Construction Change Directive

PROJECT: *(name and address)*
Highland Township Fire Station 2
PIA #18-122B

CCD INFORMATION:
Directive Number: 001
Date: July 13, 2021

“EXHIBIT A” – CCD NO. 1

FP0-01 FLOOR PLANS – FIRE PROTECTION

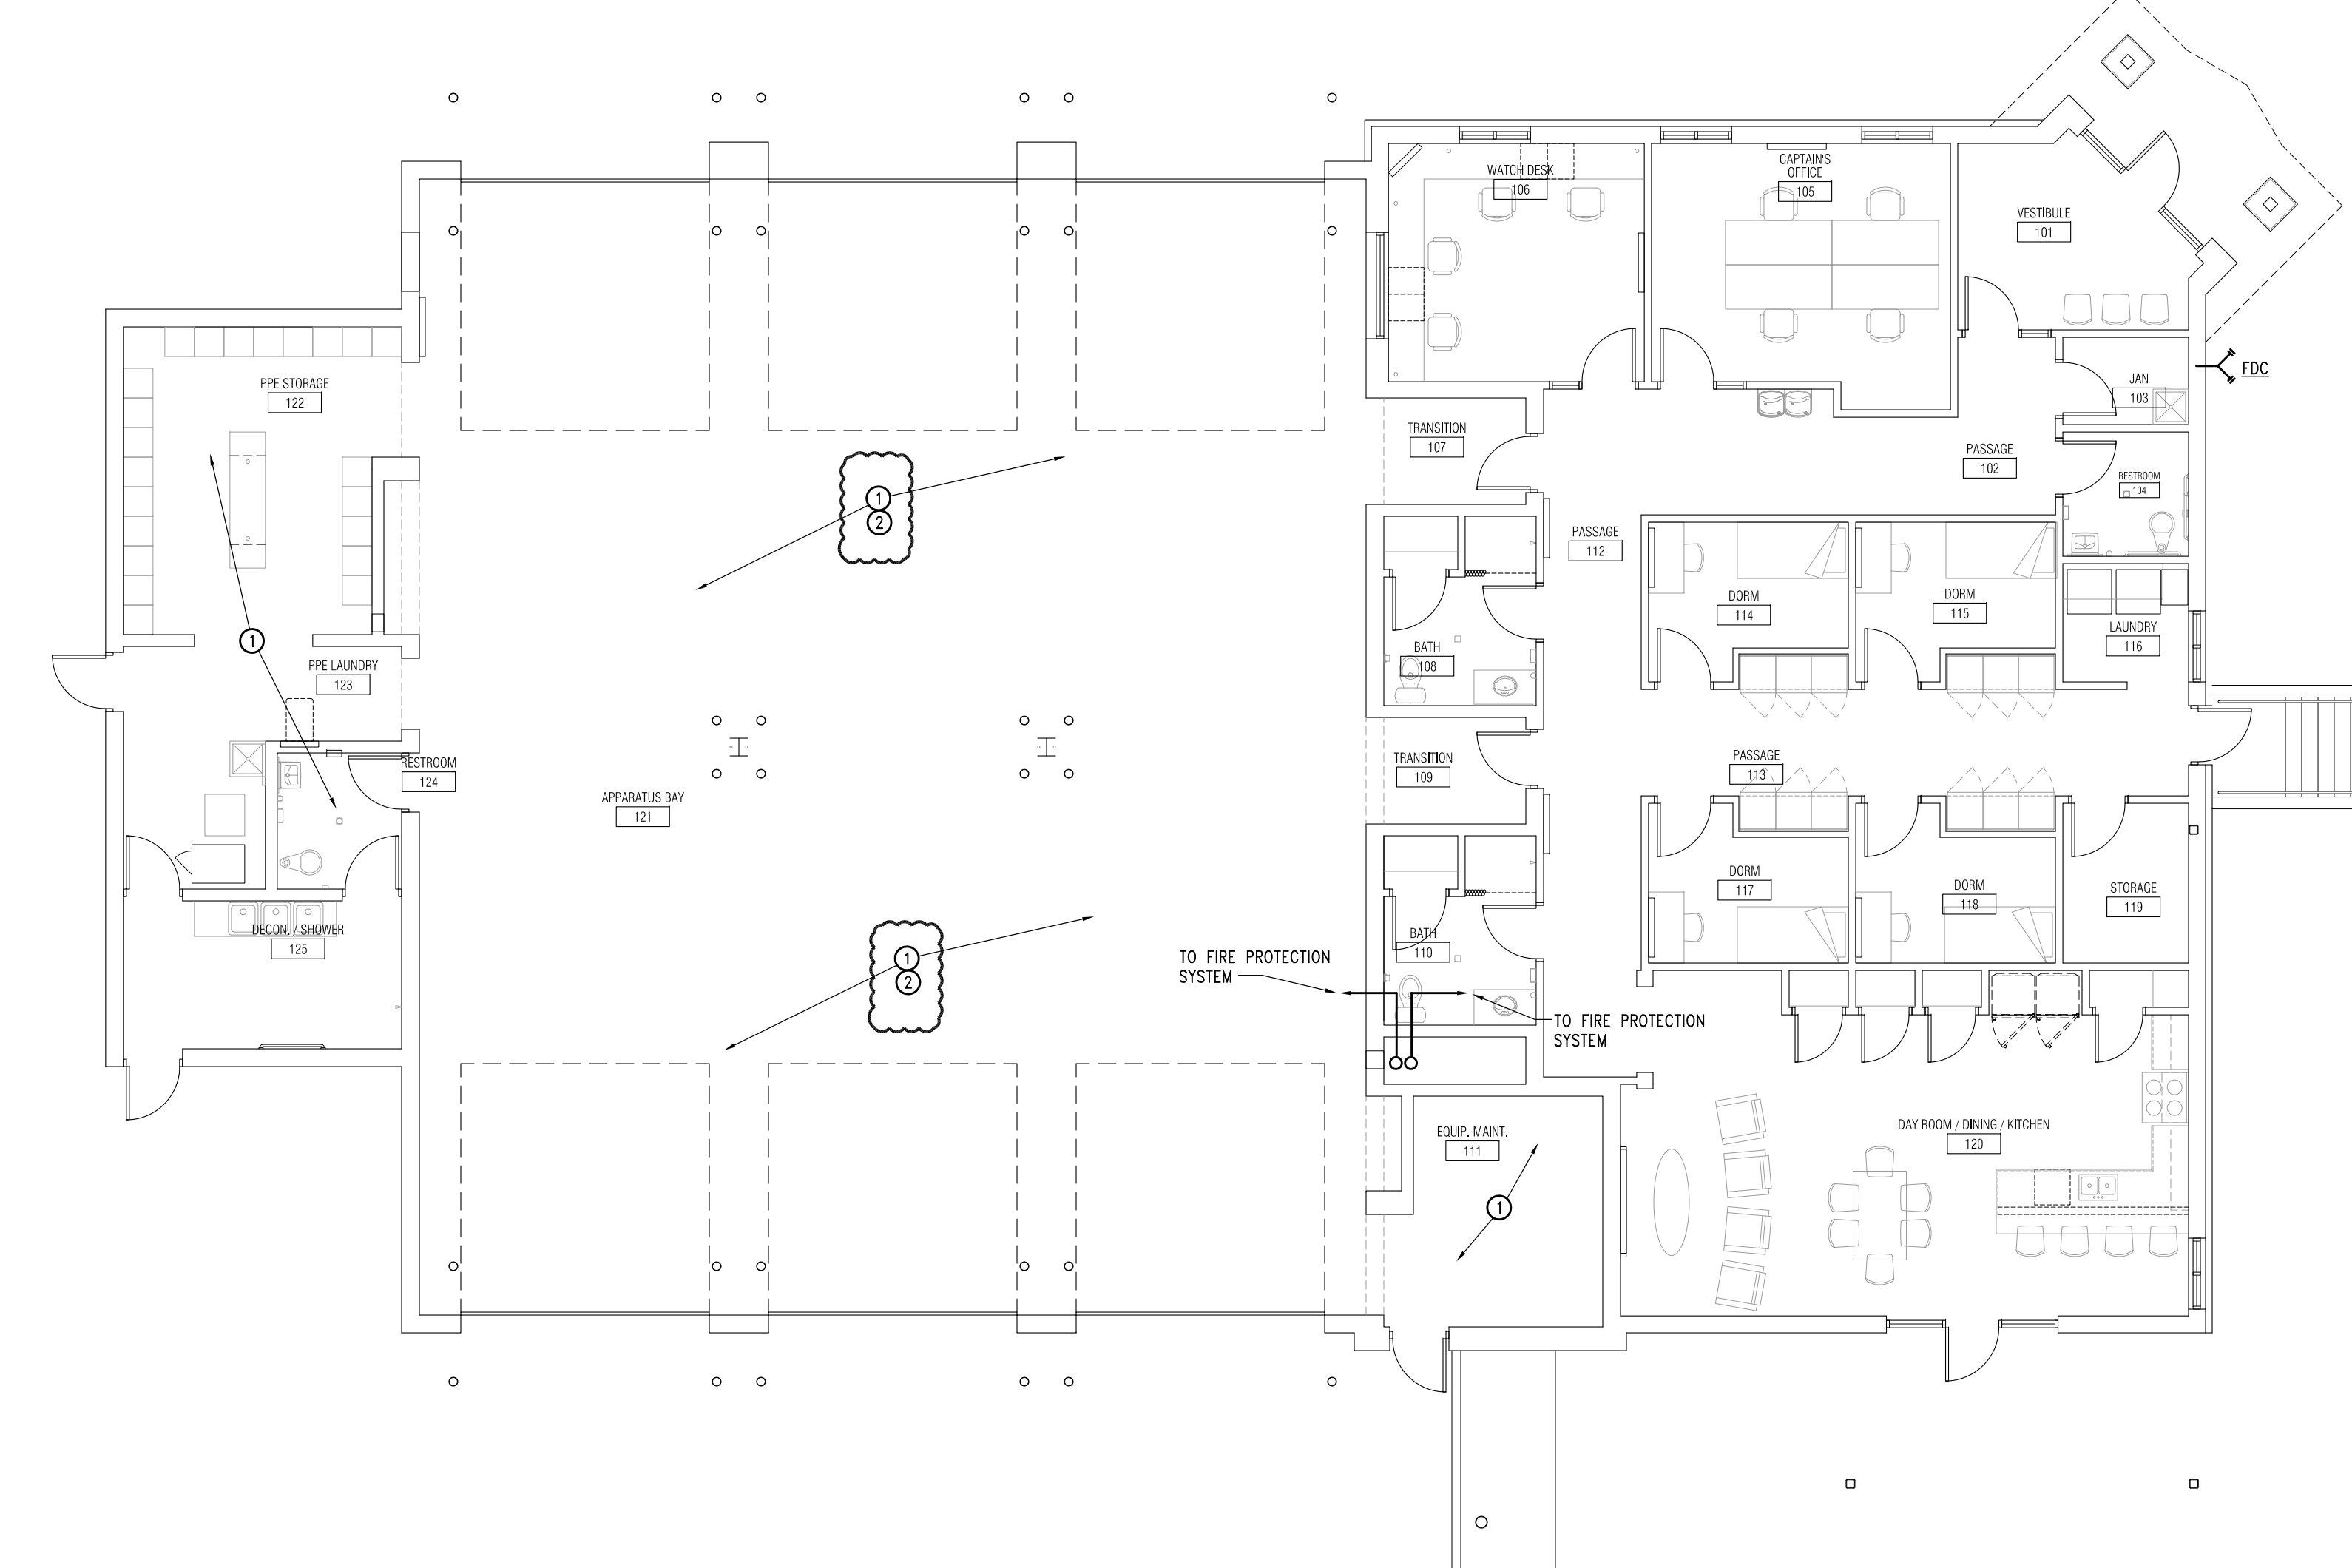
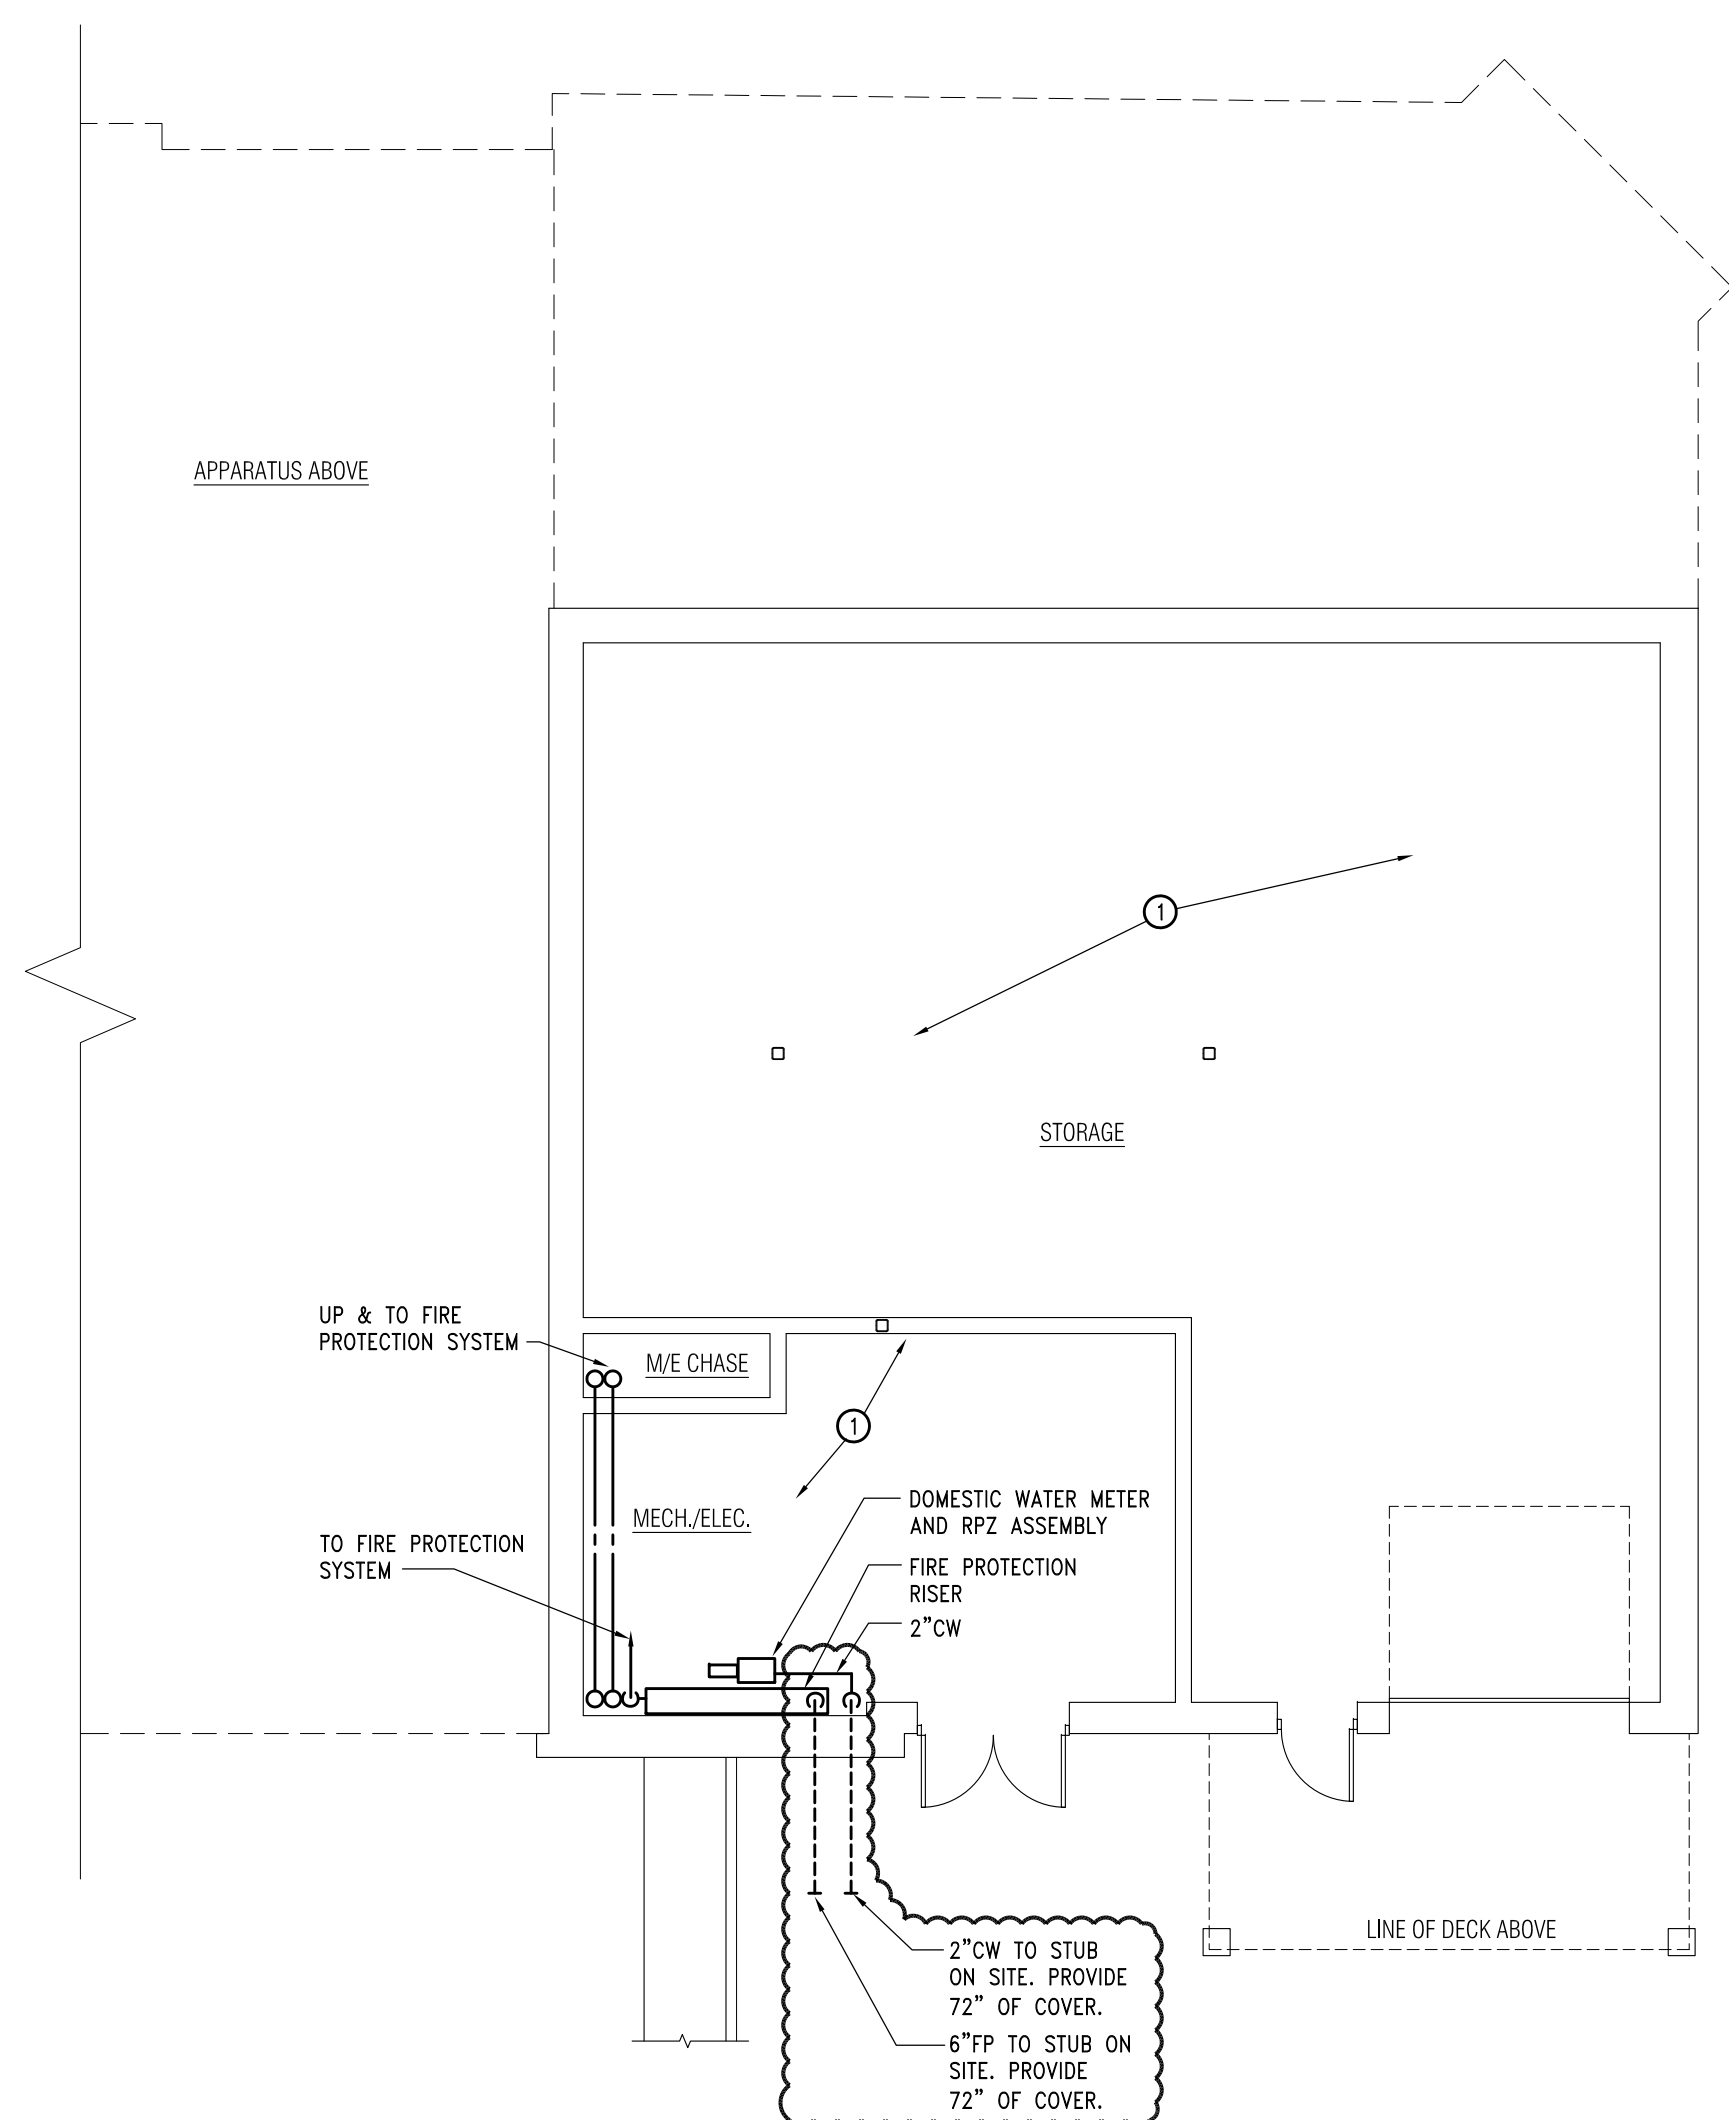
- A. Add Key Note # 2
- B. Delete one feed water stub and provide two feed water stubs. One for fire protection and one for domestic water.

M1-01 FLOOR PLANS – SANITARY & VENT

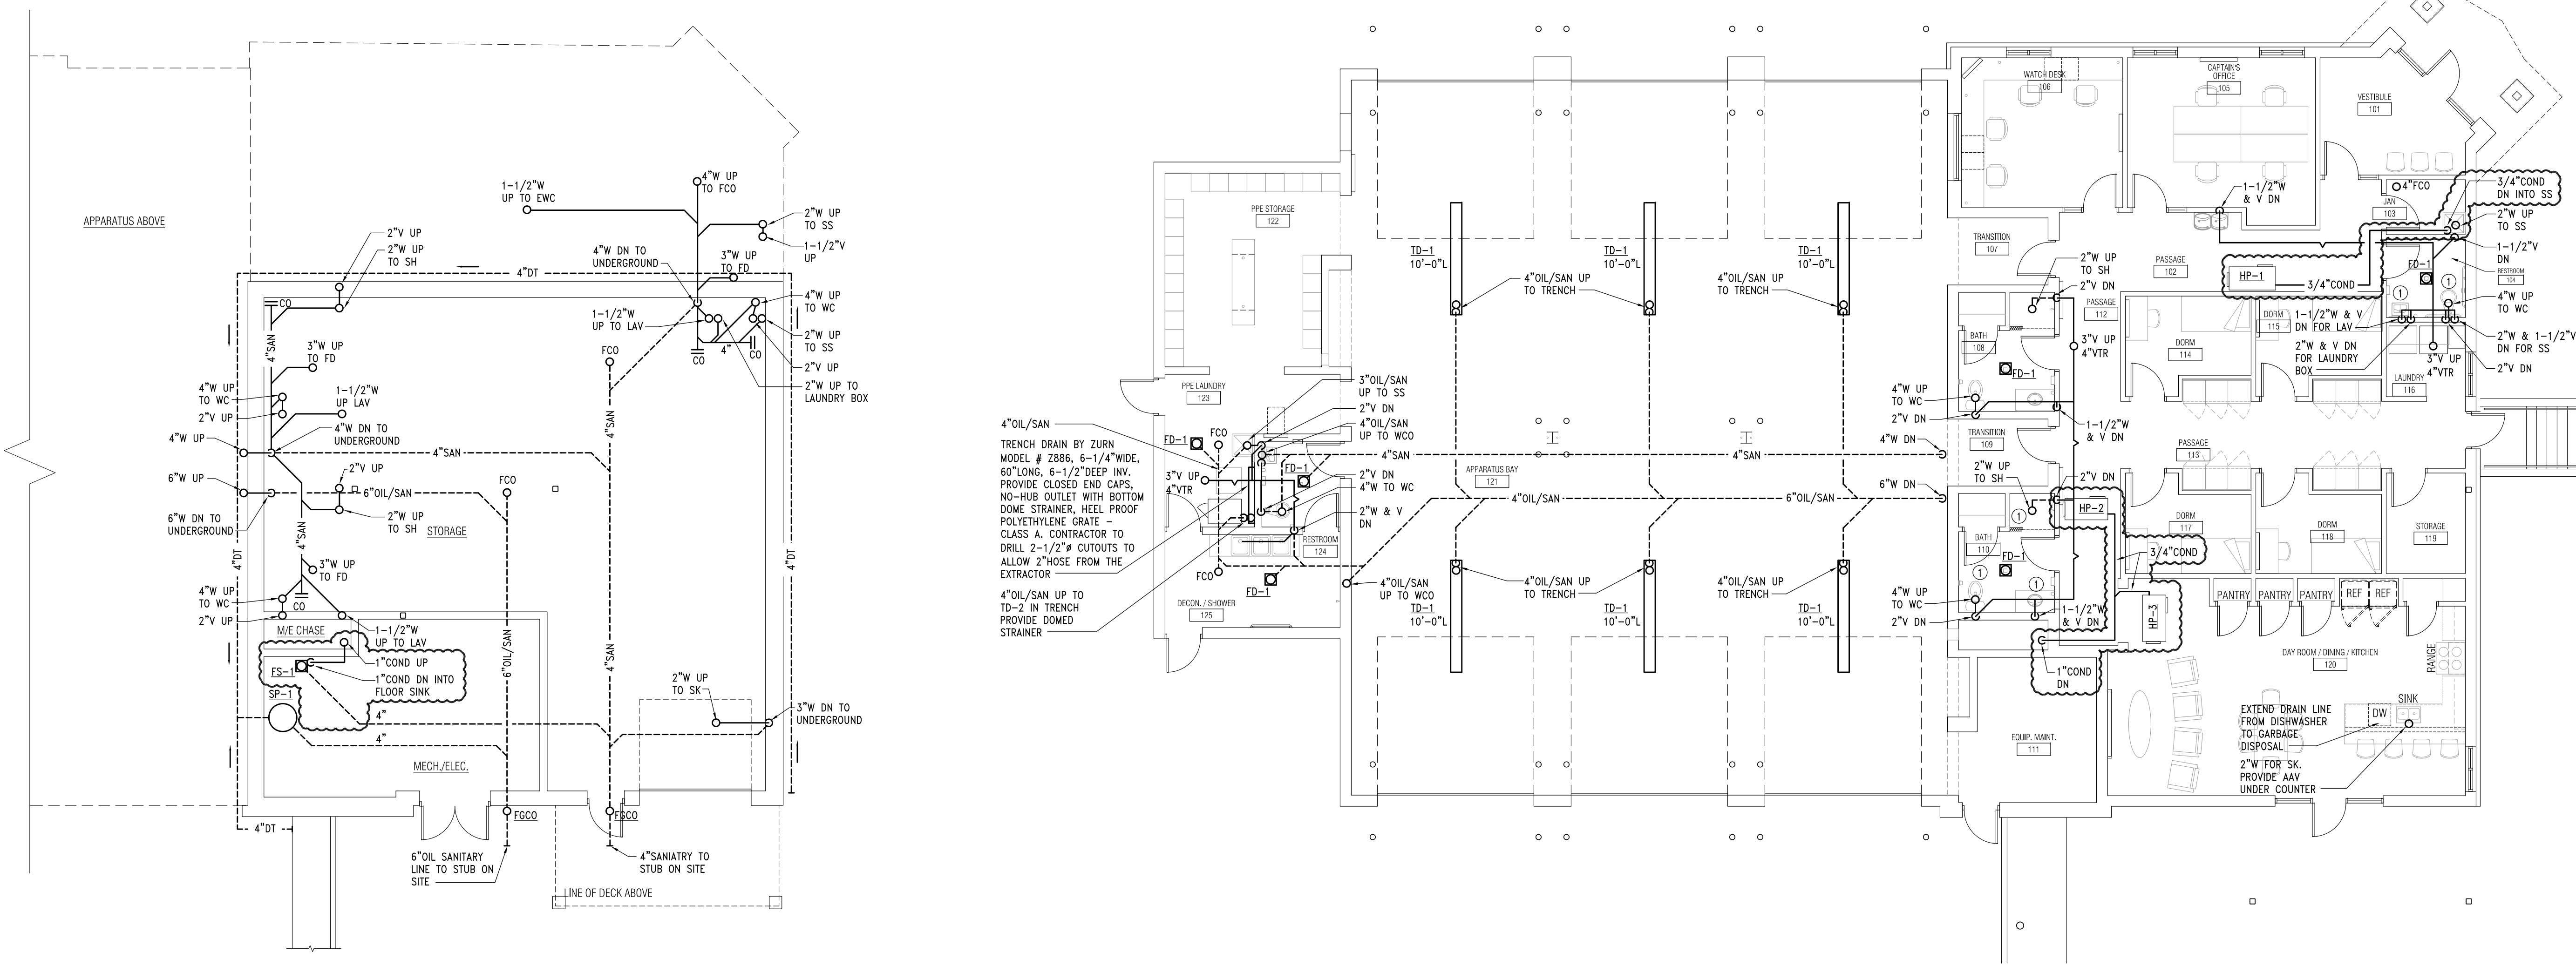
- A. Add condensate lines to heat pump units as indicated.
- B. Replace floor drain to floor sink in Mechanical room as indicated.
